## SOUTHEASTERN OAKS PHASE 1

Specific Parcel Master Plan (SPMP) approval for the Southeastern Oaks Phase 1 residential development. The project is comprised of 134 residential units.

**Staff's Recommendation:**

**Updated:** May 27, 2014

# DEVELOPMENT PLAN/PRELIMINARY PLAT

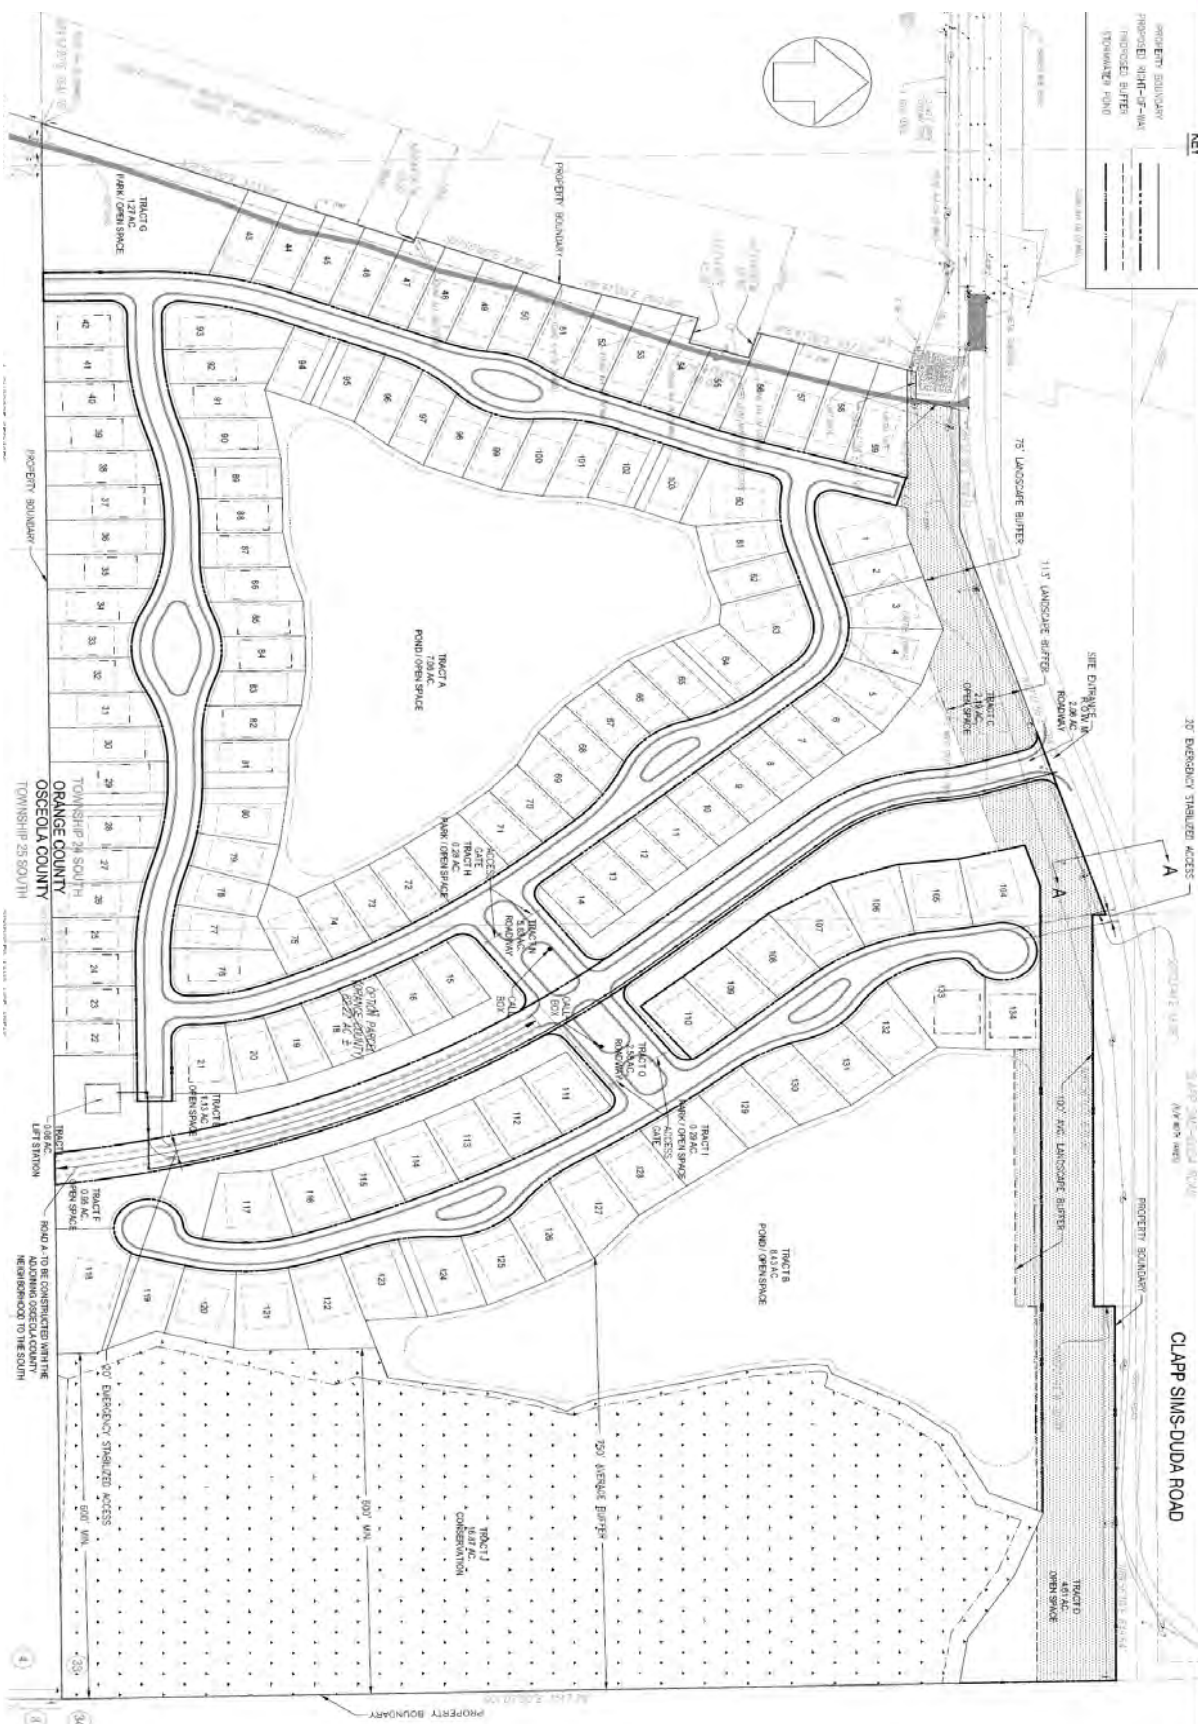
- The applicant shall revise the plan to depict the required street side yard setback of 15 feet.
- The garage shall be setback at least 30 feet from the property line.

- Corner lots shall be 10 feet wider than the minimum lot width for the rest of the lots on the block to accommodate the street side yard setback.
- Flag lots are prohibited.

- For purposes of determining setbacks, Lots 14, 15, 110 and 111 shall be considered interior lots.
- Lots 118-122 shall meet the 50 foot building setback from a retained wetland, as required by LDC Section 63.294. There is a 25 foot upland buffer within Tract J, therefore the setback from the property line is 25 feet.

1. Lot 43 is adjacent to an open space tract and shall have a minimum 15% transparency on the left side facades facing the open space.
2. Lots 1, 21, 42, 60, 76, and 93 (as noted on the application) are "reverse corner lots" and shall meet a 15' street side yard setback. These lots shall have the primary entrance orient toward the front property line (narrowest lot dimension adjacent to a street). The front facade shall be parallel to the front property line to the fullest extent possible. Street side facades shall have a minimum 15% transparency.
3. Lots 14, 15, 110, and 111 shall be considered interior lots and are not required to meet the 15% street side transparency requirements.

# LANDSCAPE PLAN

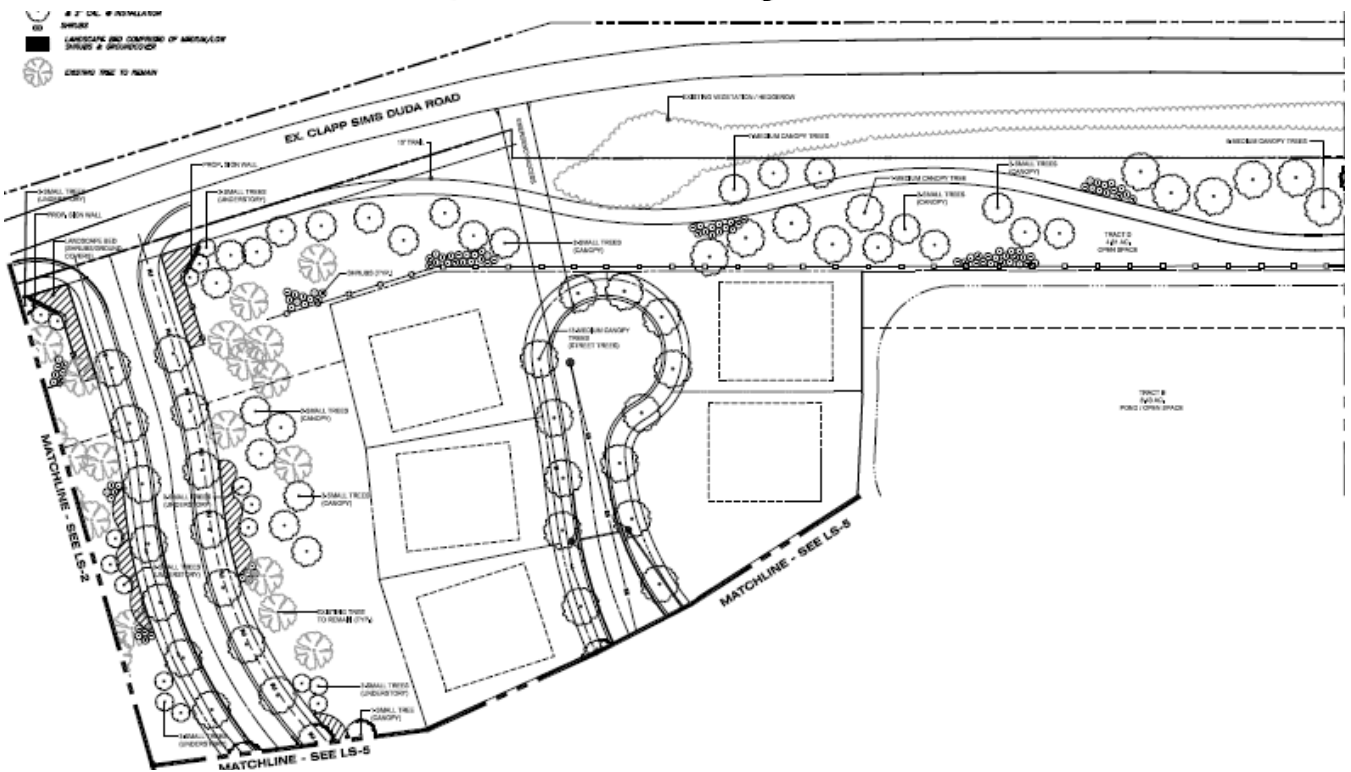
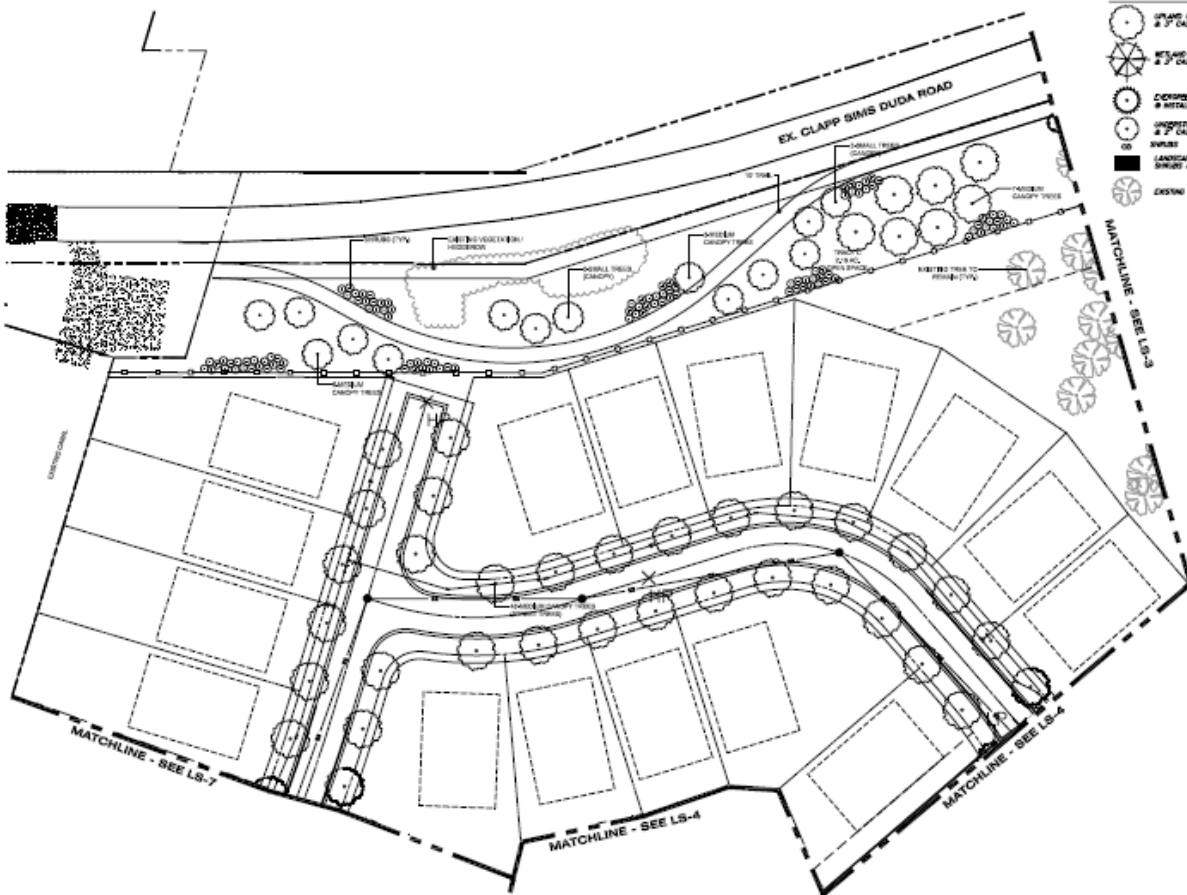
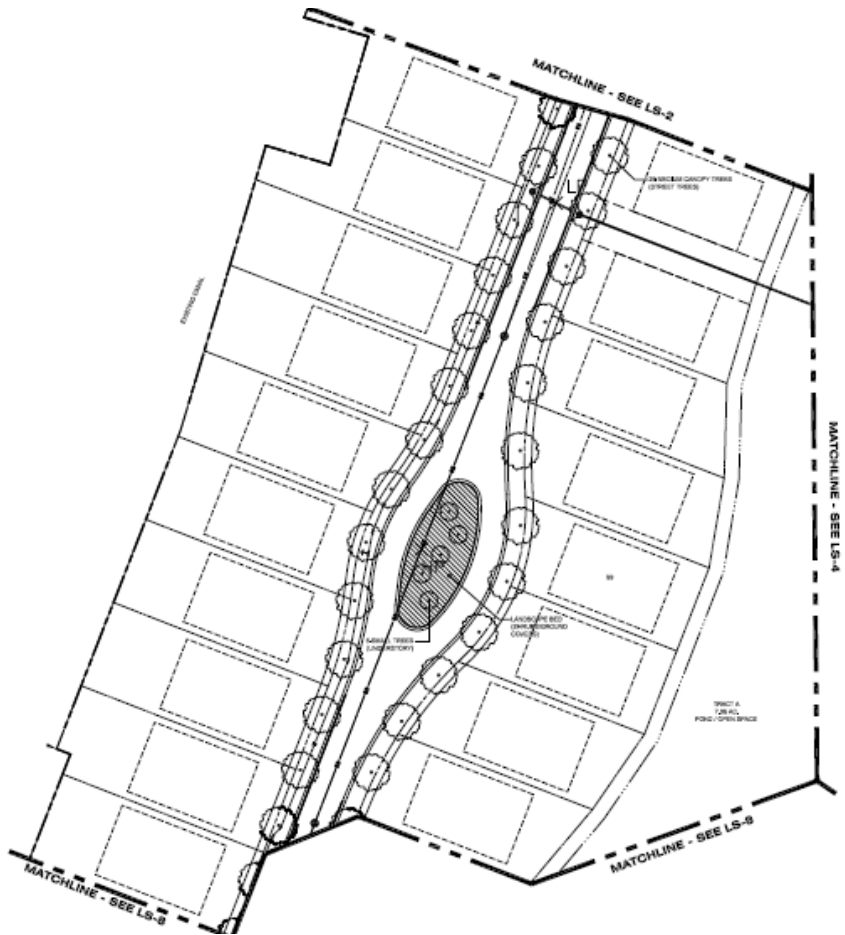
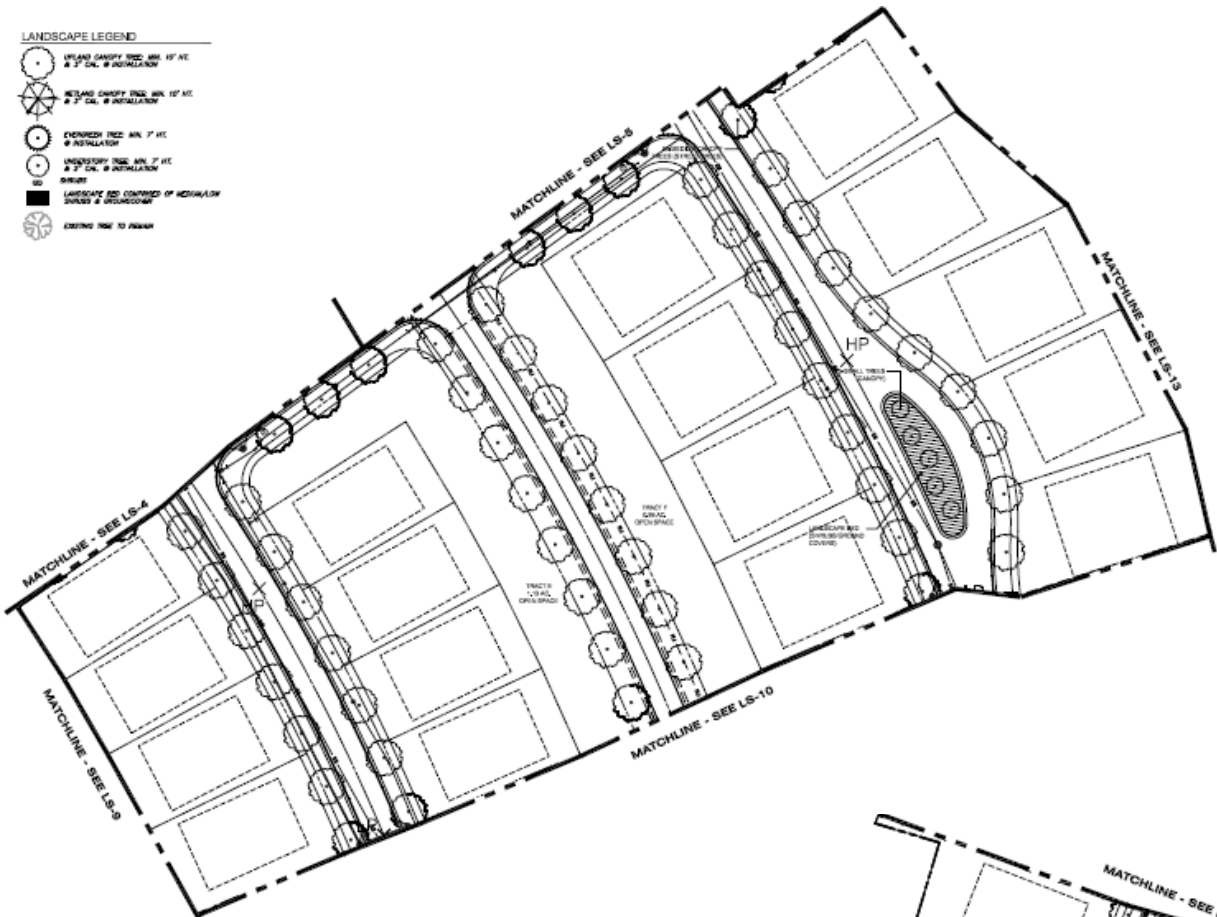
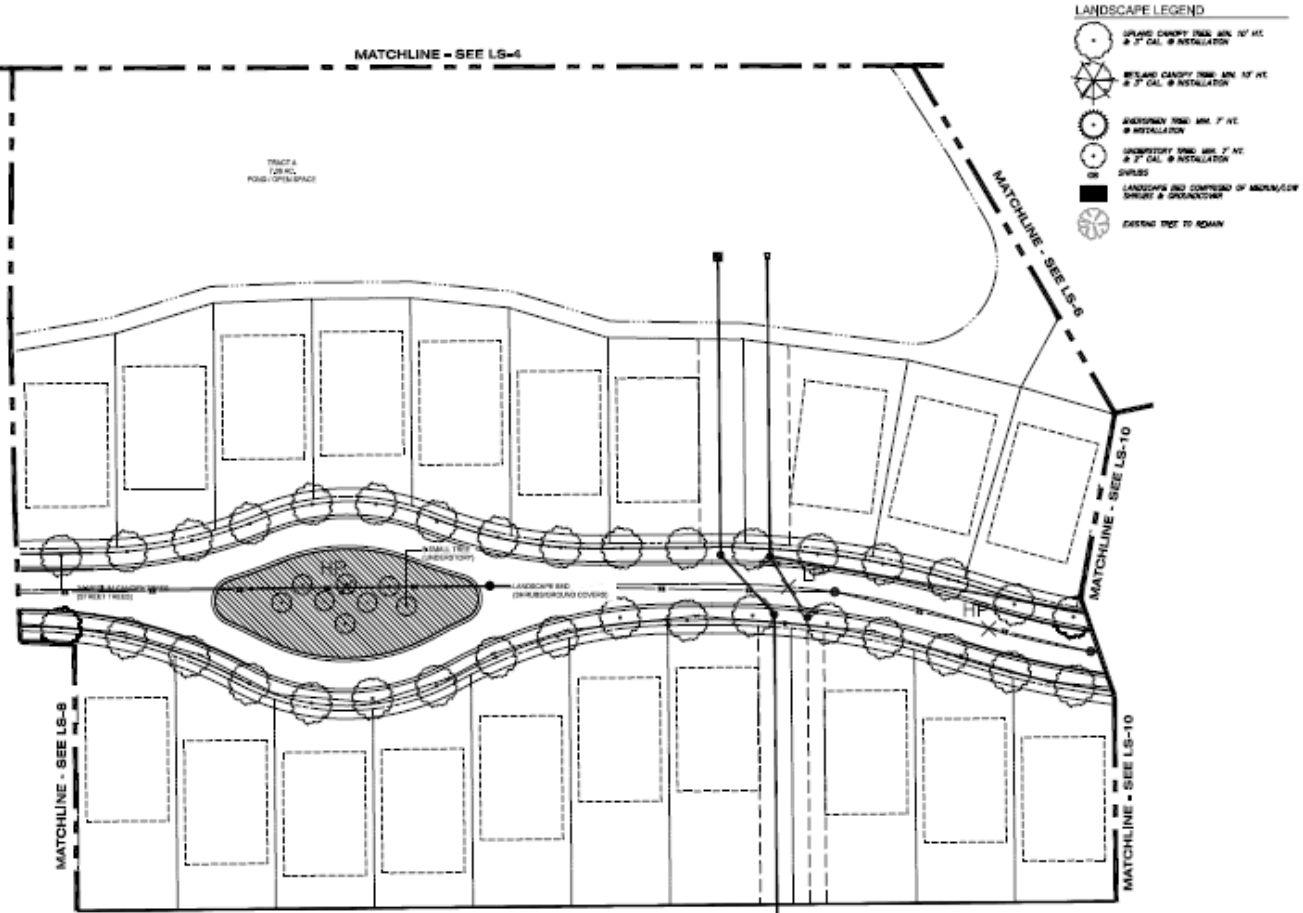
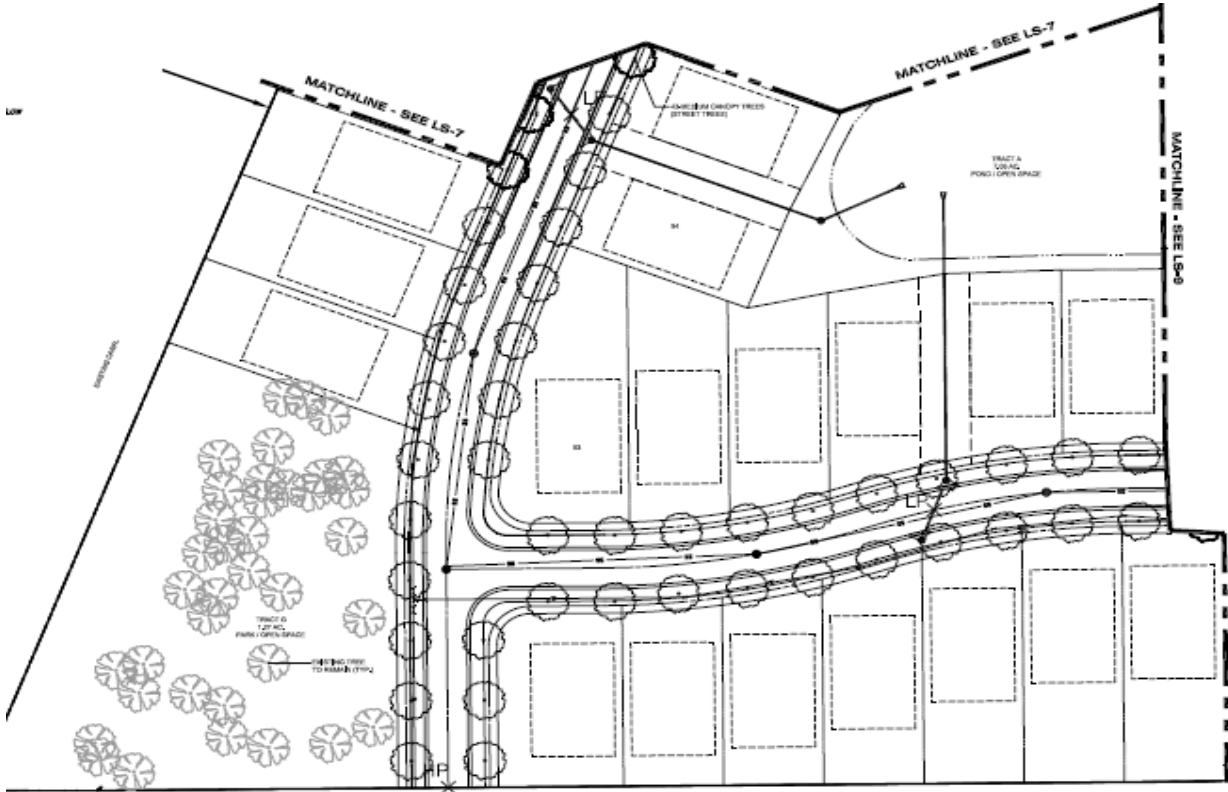
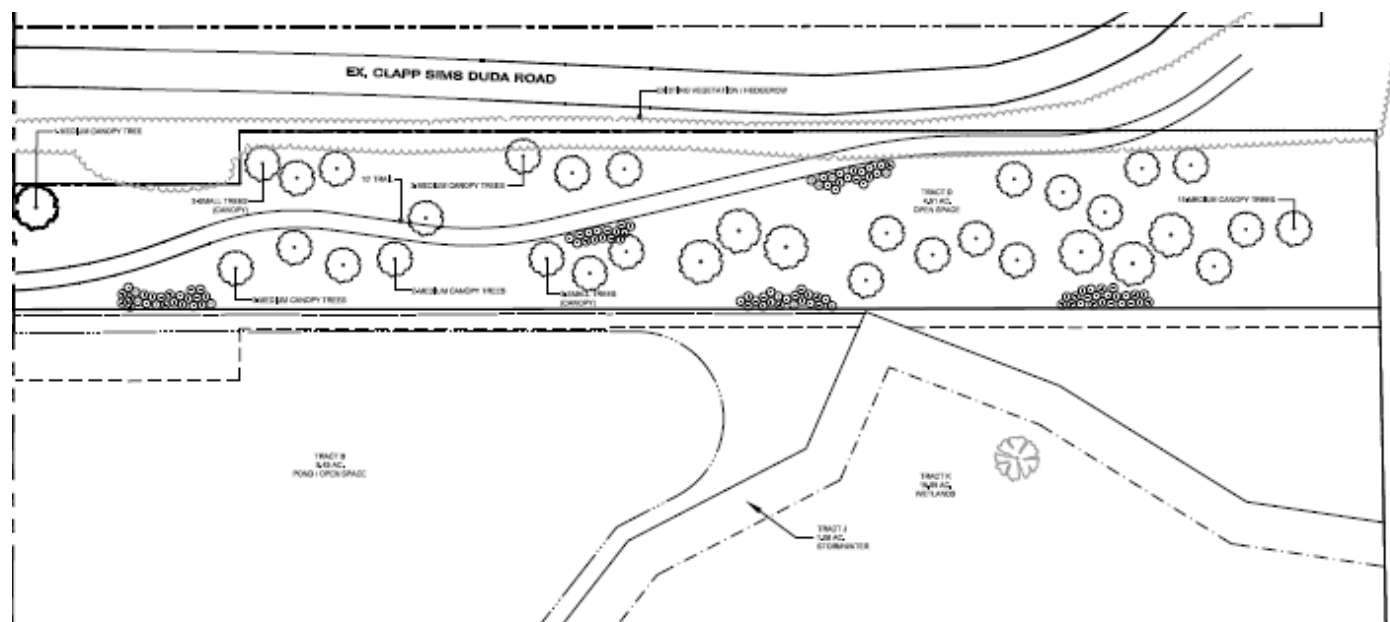
The applicant submitted a landscape plan with this application. The landscape plan can be found on pages 7-11. The landscape plan shall be developed in accordance with Chapter 60 Part 2 of the LDC. Individual lots will be reviewed at the time of building permit submittal. Street trees adjacent to single family lots may be installed concurrent with the home's landscaping. Street trees adjacent to common areas shall be installed concurrent with the infrastructure.

The landscape plan shall be developed in accordance with Chapter 60 Part 2 of the LDC. Individual lots will be reviewed at the time of building permit submittal. Street trees adjacent to single family lots may be installed concurrent with the home's landscaping. Street trees adjacent to common areas shall be installed concurrent with the infrastructure.

## ROAD CROSS SECTIONS

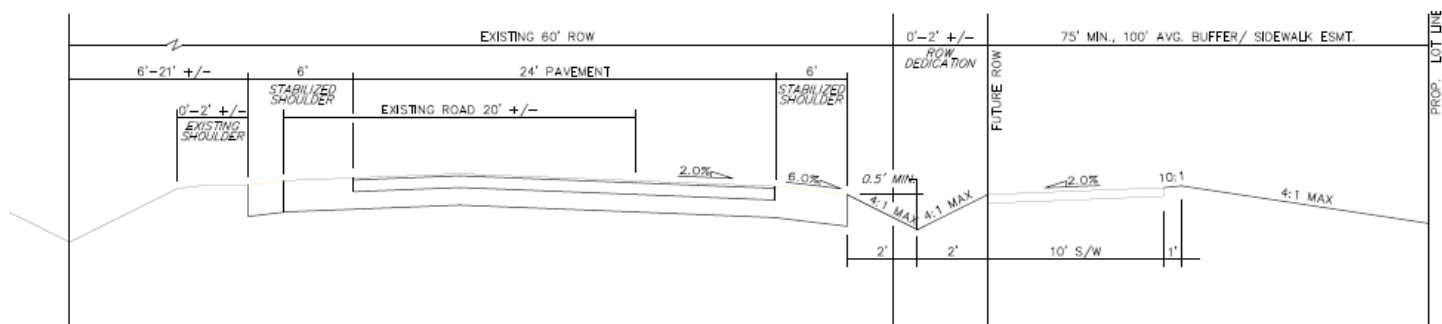
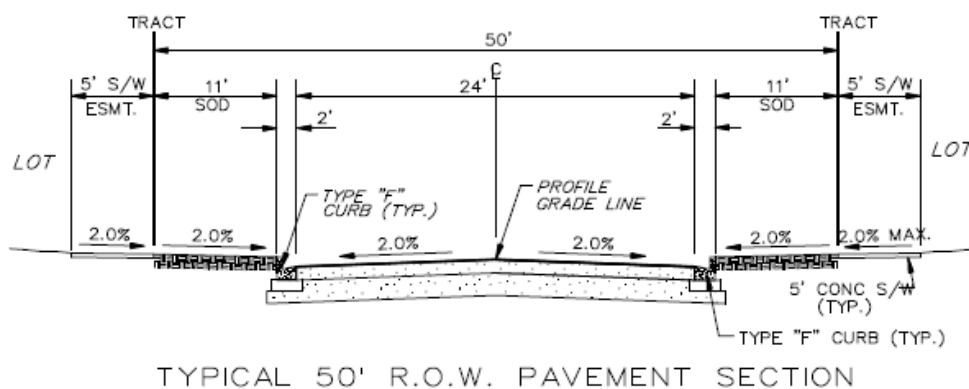
The proposed typical road section needs to be designed and constructed in accordance with the City of Orlando standards. The typical road section is 50 feet of right-of-way with two (2) 5' wide sidewalk easements, 24 feet of pavement with 2" FDOT Type S-III Asphalt, two (2) feet of standard curb and gutter each side. The Sub-base shall have a stabilization of 95 FBV (Florida Bearing Value) in addition to the stated compaction.

Clarify road ownership, maintenance and cross sections.
